Re: 339 West Gorham Street: Oliv Madison

Attached is a minor amendment packet for the Oliv Madison Project. These changes address some program elements (expanded amenity), design refinements, and adding solar to the project. The packet illustrates the changes between the Original SIP document and the proposed amendments. The site plan review/building permit set elevations are also included for reference to show what was approved with the building permit.

UDC MINOR REVISIONS

ōliv MADISON 339 W GORHAM STREET

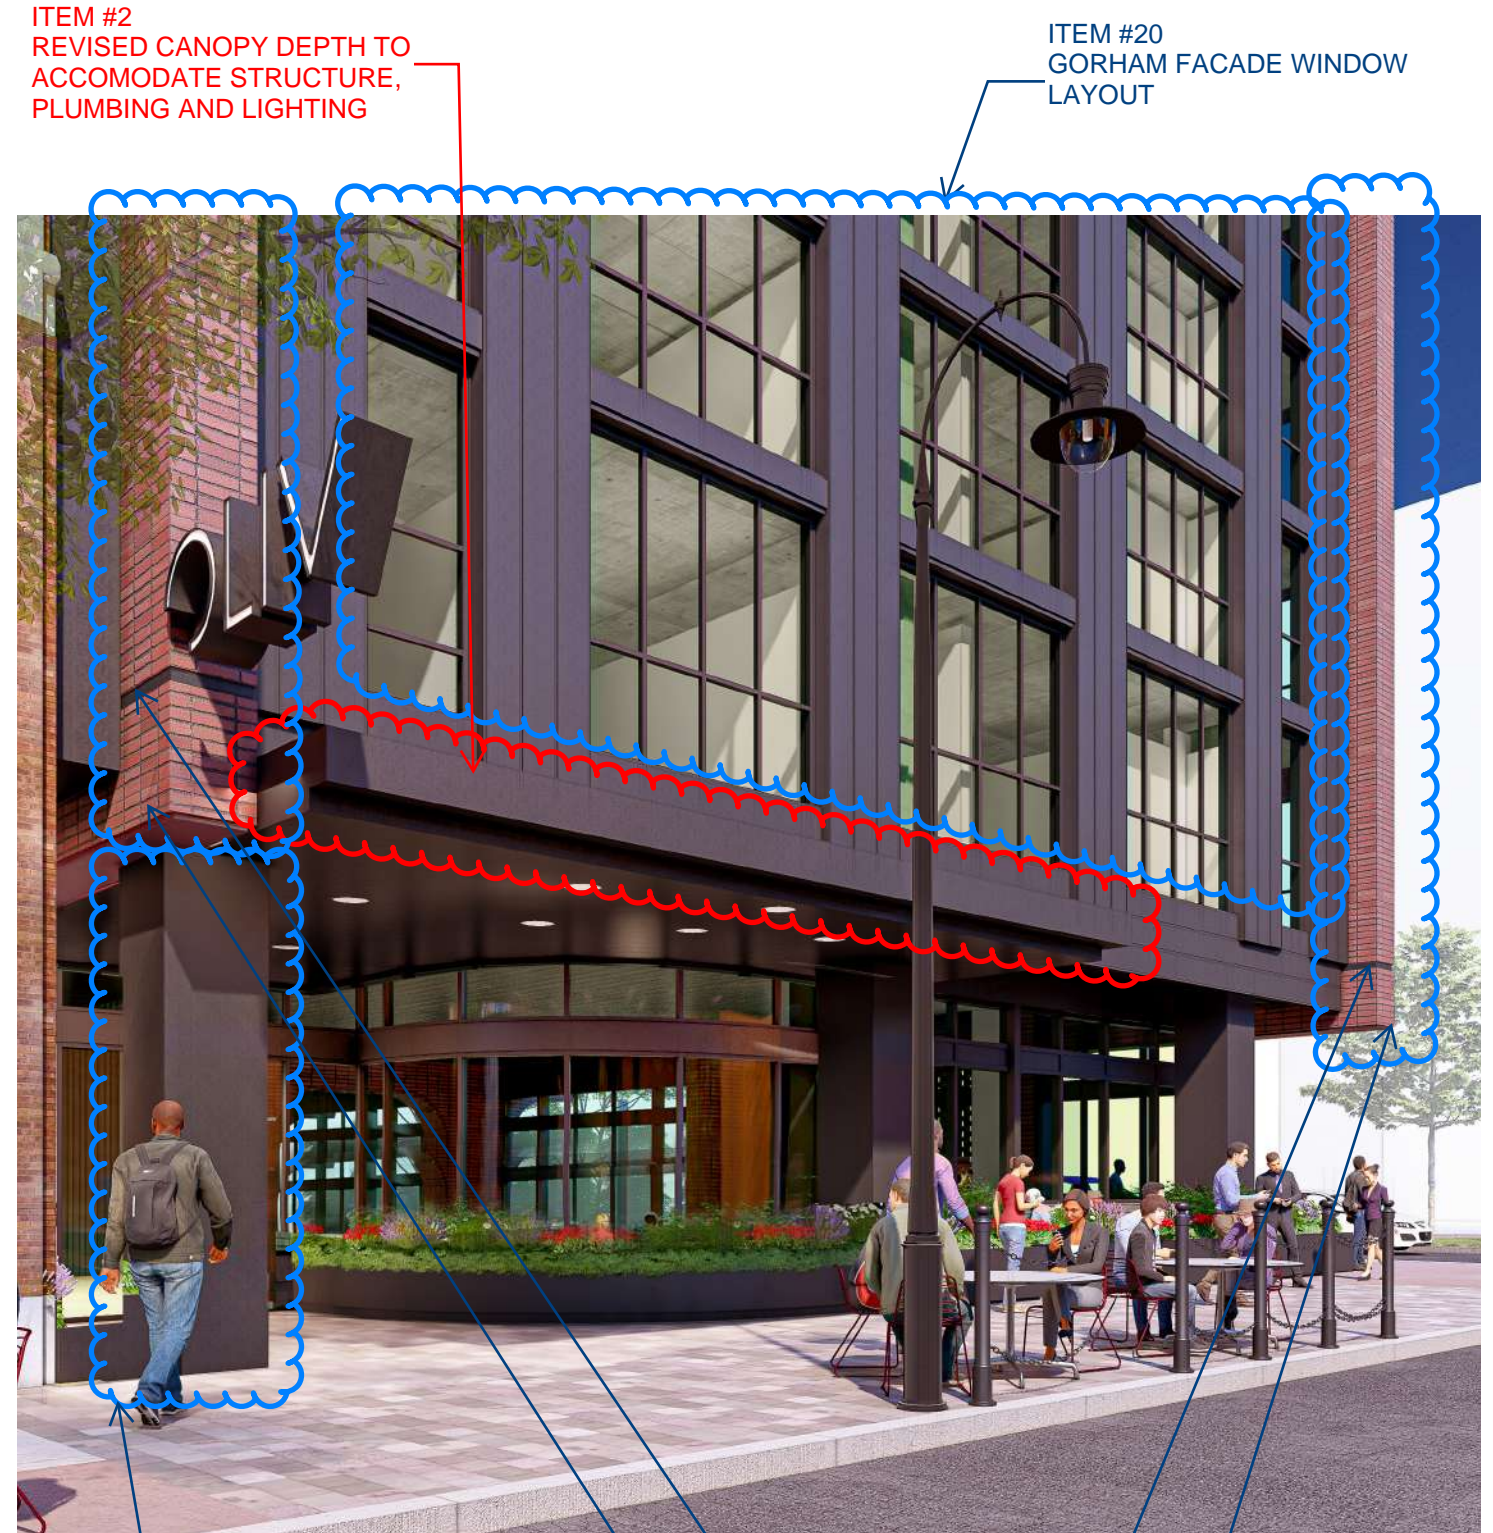
ITEM #7
WIDTH AND DEPTH
REVISED FOR
CONSTRUCTABILITY

ITEM #10
BLACK BRICK REVEAL

ITEM #2
CANOPY REVISED FOR
CONSTRUCTABILITY

ITEM #1
PAINTED CURVED STEEL
ELEMENT FOR
CONSTRUCTABILITY

ITEM #8
STRUCTURAL COLUMNS REQUIRED
FOR CONSTRUCTABILITY

ITEM #9
ADJUSTMENTS TO
SCREEN WALL FOR
LATERAL BRACING,
CONSTRUCTABILITY
AND MAINTENANCE

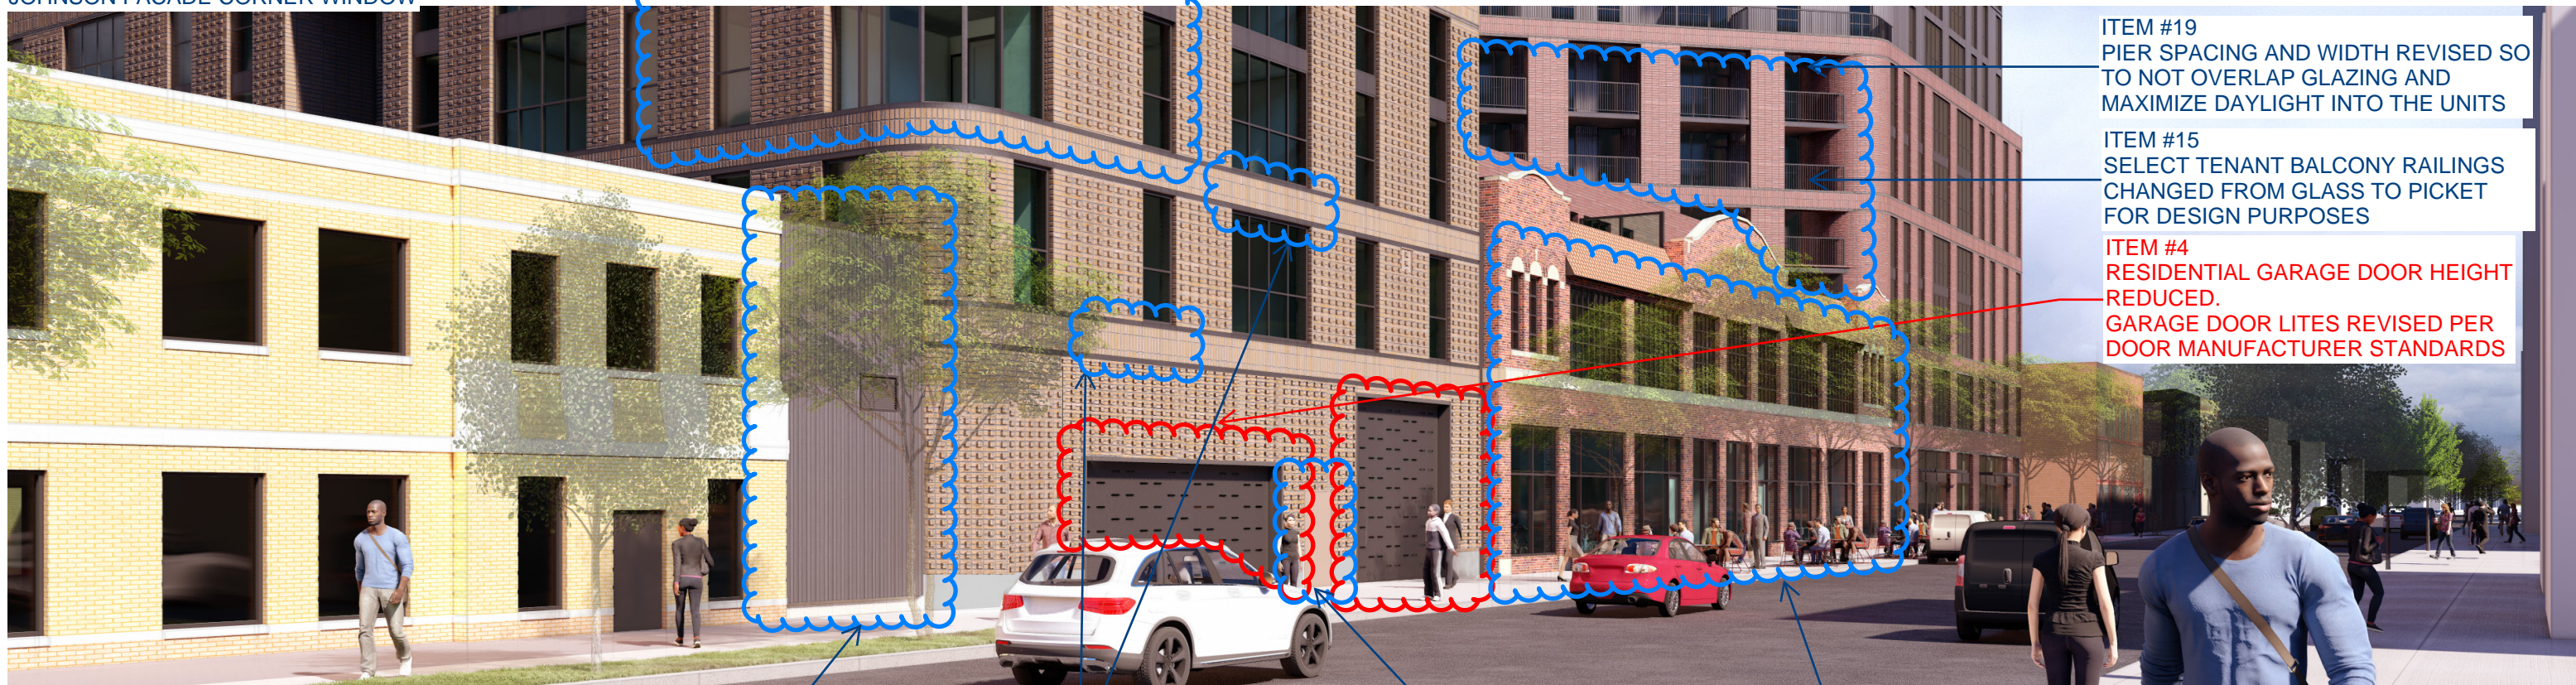
ITEM #20
GORHAM FACADE WINDOW LAYOUT

ITEM #7
WIDTH AND DEPTH
REVISED FOR
CONSTRUCTABILITY

ITEM #2
REVISED CANOPY DEPTH TO
ACCOMODATE STRUCTURE,
PLUMBING AND LIGHTING

ITEM #16
JOHNSON FACADE CORNER WINDOW

ITEM #19
PIER SPACING AND WIDTH REVISED SO
TO NOT OVERLAP GLAZING AND
MAXIMIZE DAYLIGHT INTO THE UNITS

ITEM #15
SELECT TENANT BALCONY RAILINGS
CHANGED FROM GLASS TO PICKET
FOR DESIGN PURPOSES

ITEM #4
RESIDENTIAL GARAGE DOOR HEIGHT
REDUCED.
GARAGE DOOR LITES REVISED PER
DOOR MANUFACTURER STANDARDS

ITEM #17
METAL PANEL WAS NOT VISIBLE IN ORIGINAL RENDERING
DUE TO ERROR IN SETBACK OF THE FIREHOUSE. WAS
INCLUDED IN ADOPTED ELEVATIONS AND PLANS.

ITEM #10
1/2" BRICK REVEAL DEFINED

ITEM #18
EGRESS DOOR
TO STAIR 2

ITEM #24
HISTORIC FACADE
UPDATED TO REFLECT
LASER SCAN

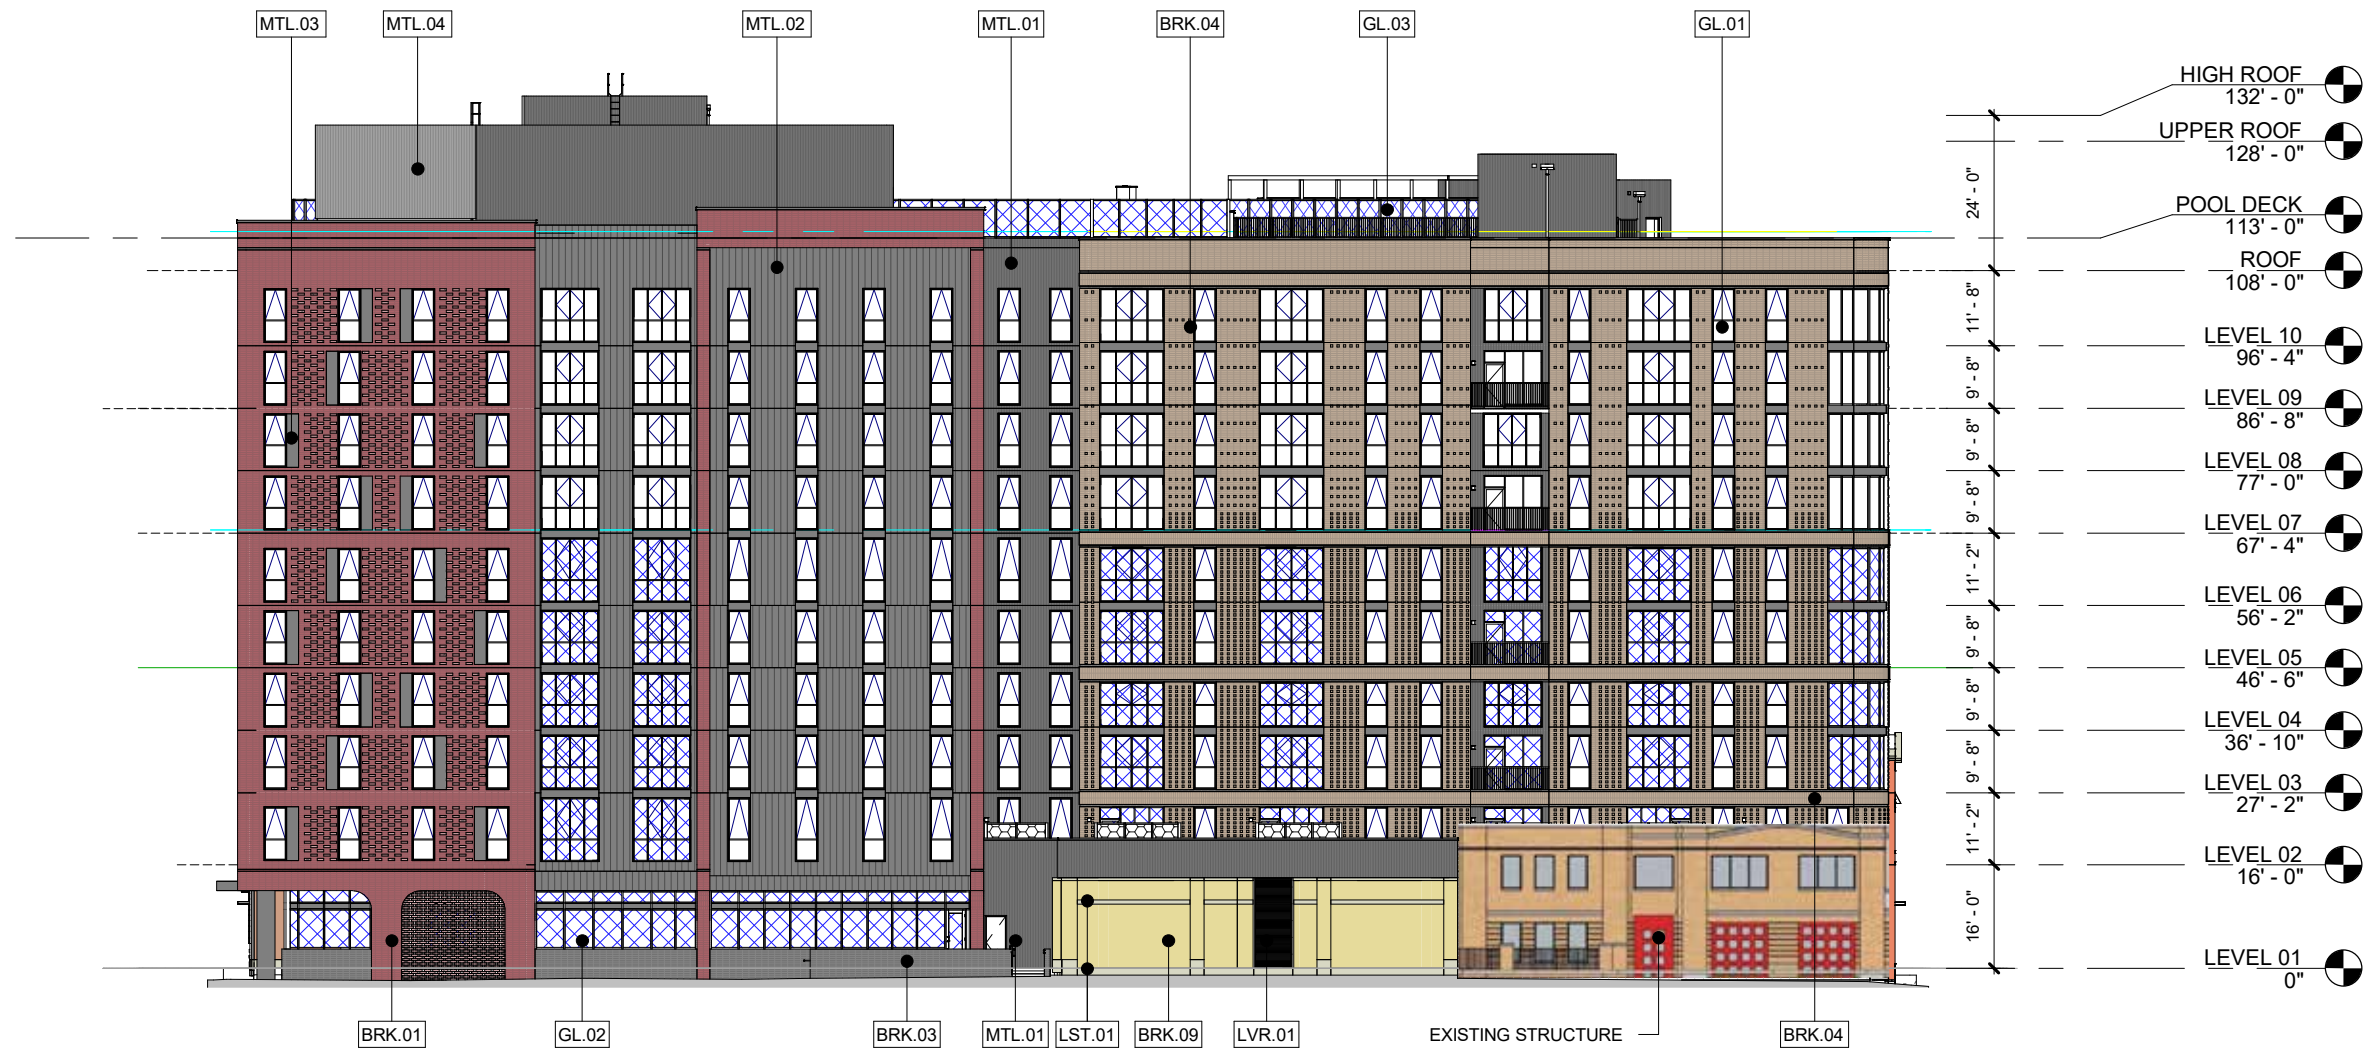
ITEM #28
WINDOW SPACING ADJUSTED TO ALIGN WITH
UNIT LAYOUTS - TYPICAL ON ALL FACADES

ITEM #27
GLASS RAILING DEVELOPED FURTHER
THROUGHOUT BUILDING - TYPICAL ON ALL
FACADES

ITEM #15
SELECT TENANT BALCONY RAILINGS
CHANGED FROM GLASS TO PICKET
FOR DESIGN PURPOSES

ITEM #20
GORHAM FACADE WINDOW
LAYOUT

ITEM #29
JOHNSON STREET ALLEY
SETBACK

ITEM #3
PROPOSING ALUMINUM
LOUVERED CANOPIES AT
RETAIL STOREFRONTS.

ITEM #13
PARAPETS INCREASED IN
HEIGHT TO ACCOMMODATE
REQUIRED ROOF ASSEMBLY

ITEM #26
DEEPER METAL BAND FOR
CONSTRUCTABILITY

ITEM #1
PAINTED STEEL PLATE FOR
CONSTRUCTABILITY

ITEM #2
CANOPY REVISED FOR
CONSTRUCTABILITY

ITEM #1
PAINTED STEEL PLATE FOR
CONSTRUCTABILITY

ITEM #3
PROPOSING ALUMINUM
LOUVERED CANOPIES AT
RETAIL STOREFRONTS.

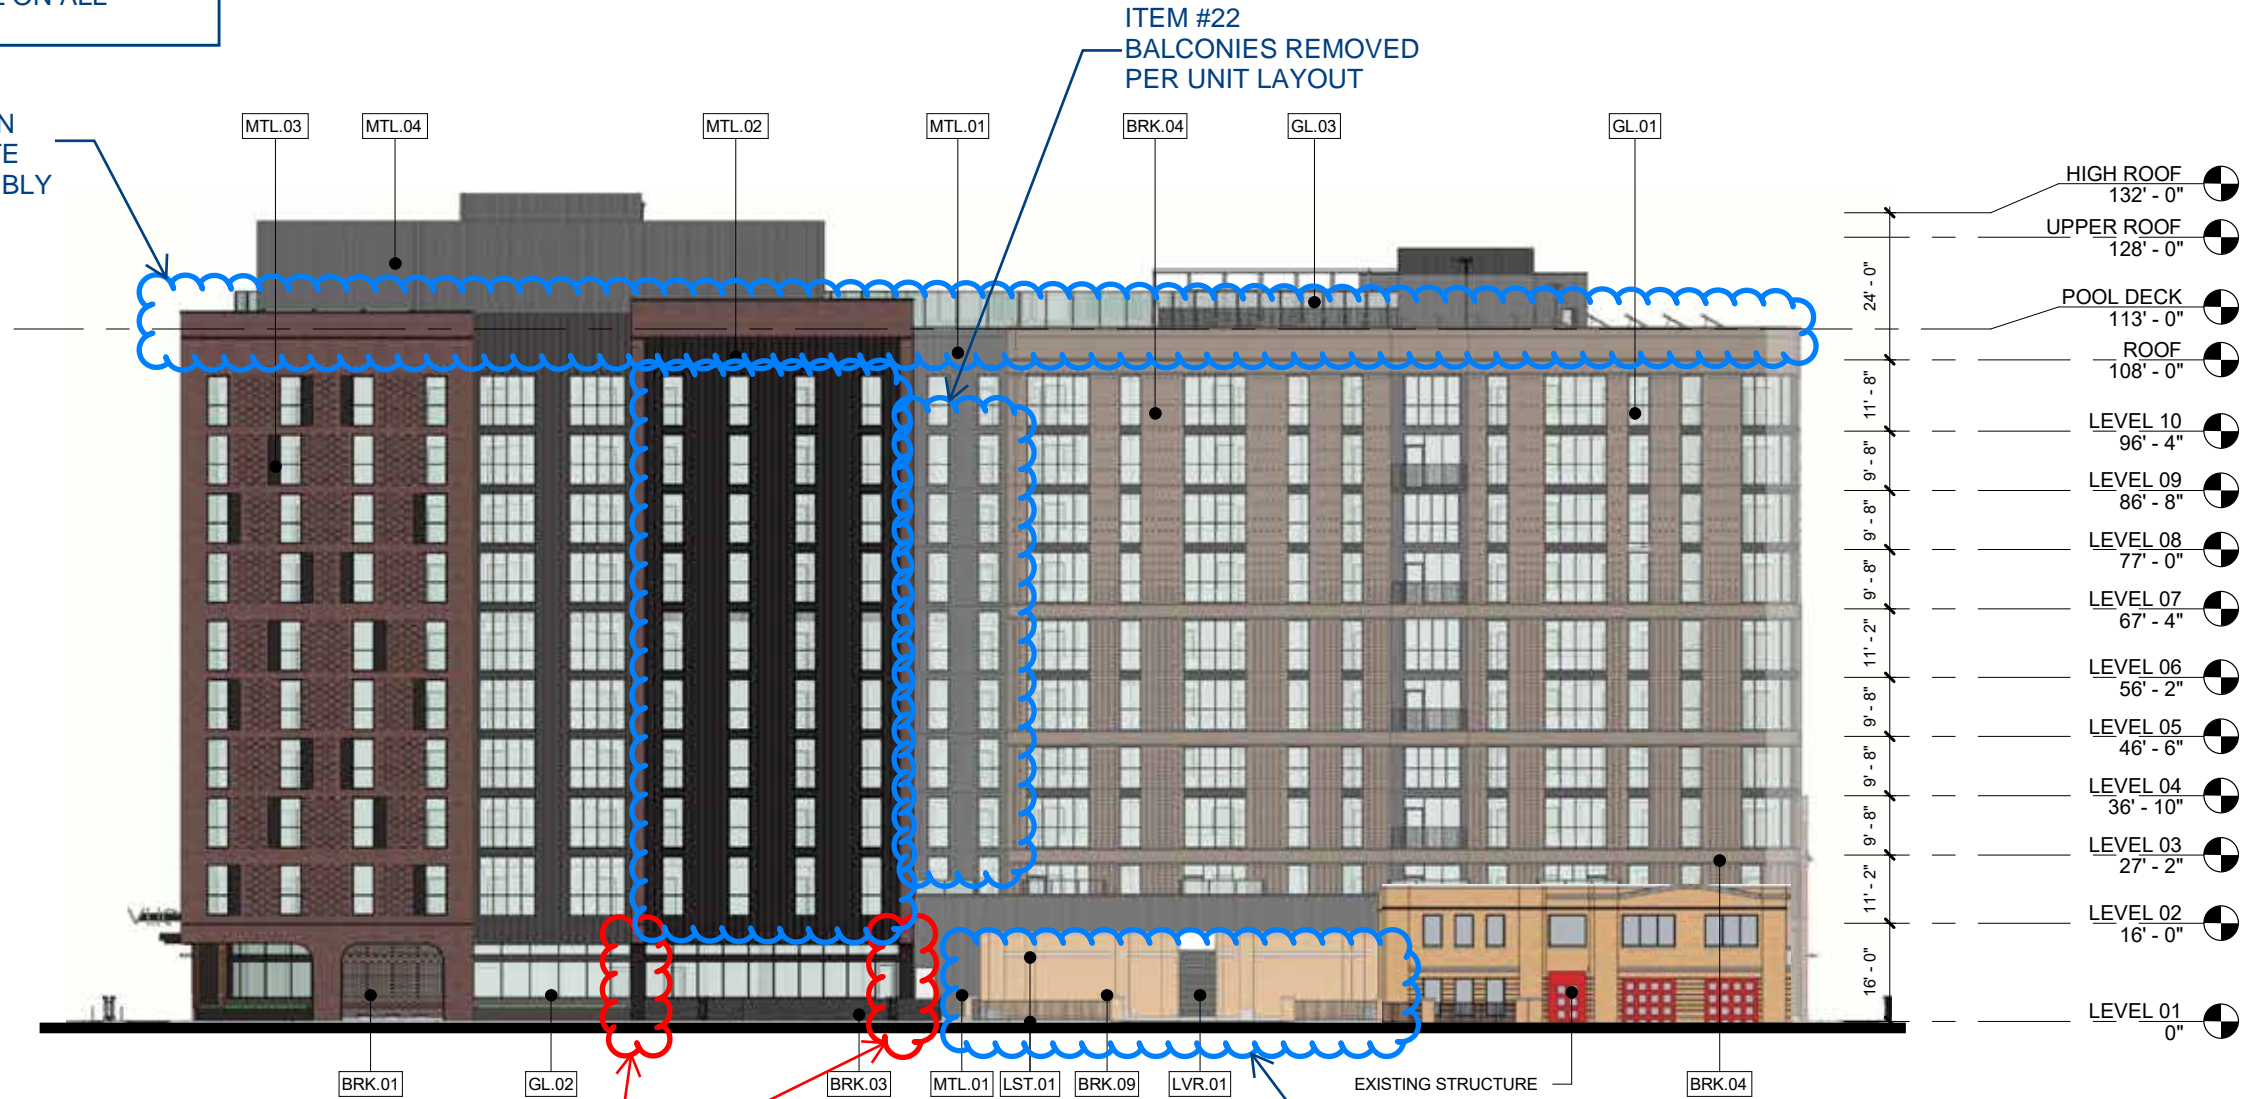
ITEM #28
WINDOW SPACING ADJUSTED TO ALIGN WITH
UNIT LAYOUTS - TYPICAL ON ALL FACADES

ITEM #10
BLACK BRICK
REVEAL

ITEM #27
GLASS RAILING DEVELOPED FURTHER
THROUGHOUT BUILDING - TYPICAL ON ALL
FACADES

ITEM #13
PARAPETS INCREASED IN
HEIGHT TO ACCOMMODATE
REQUIRED ROOF ASSEMBLY

ITEM #22
BALCONIES REMOVED
PER UNIT LAYOUT

ITEM #1
PAINTED STEEL PLATE FOR
CONSTRUCTABILITY

ITEM #21
METAL PANEL CHANGED TO BRICK THAT
MATCHES FIREHOUSE BRICK
